# Technical Service Information

## **FORD 4EAT PROBE** **BIND UP IN REVERSE AND** **MANUAL LOW**

Figure 1

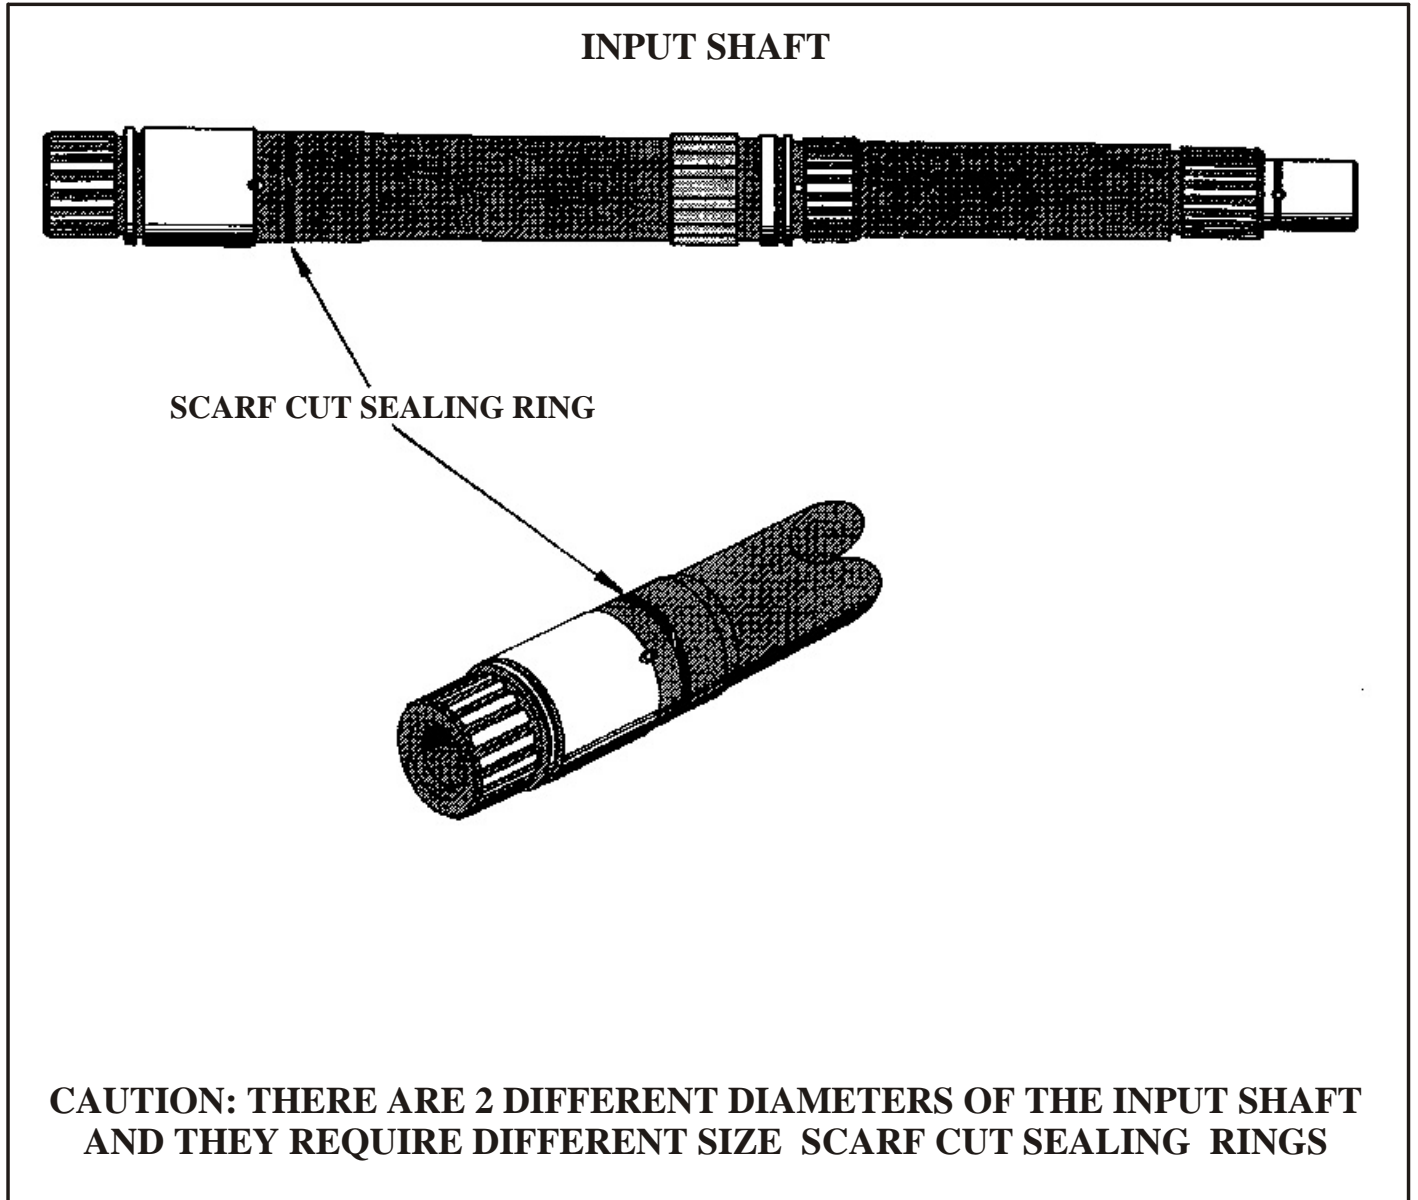
- COMPLAINT:** Bind-up when the selector lever is placed in Reverse or the Manual Low positions. Also may display premature 3-4 clutch failure.
- CAUSE:** The cause may be the scarf-cut Teflon sealing ring on the input shaft leaking, which would allow converter release oil into the 3-4 clutch passage and apply the 3-4 clutch pack (See Figure 1).
- CORRECTION:** Install a new Teflon scarf-cut sealing ring in the input shaft groove, as shown in Figure 1.  
**CAUTION: THERE ARE TWO DIFFERENT DIAMETERS OF THE G4A-EL INPUT SHAFT AND THEY REQUIRE DIFFERENT SIZE SEALING RINGS.**  
One shaft has 21 turbine splines, and the journal diameter behind the splines is .902" in diameter. One shaft has 25 turbine splines, and the journal diameter behind the splines is 1.092" in diameter. Be very careful to select the proper size scarf-cut sealing ring for the input shaft.
